ALLIGATOR TOURS™

MANUAL UPDATE:

Your Alligator Tours Airboat now comes with a new SuperTigre® .27ci engine (SUPG0727) and AquaCraft Airboat exhaust system (AQUB6432).

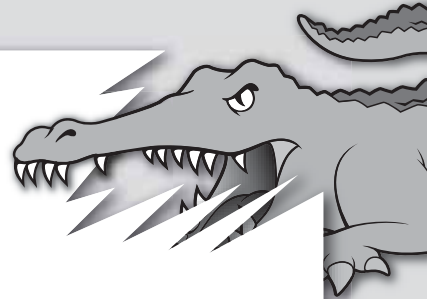
The new engine and exhaust feature:

- ▶ Better engine cooling
- ▶ Remote mounted high speed needle valve (HSN)
- ▶ Spring on exhaust header system for easy maintenance
- ▶ Lower center of gravity for improved boat handling

It's also important to note that the new engine's factory needle settings are:

- ▶ 2-1/2 turns out for the high speed needle (HSN)
- ▶ 1 turn out for the low speed needle (LSN)
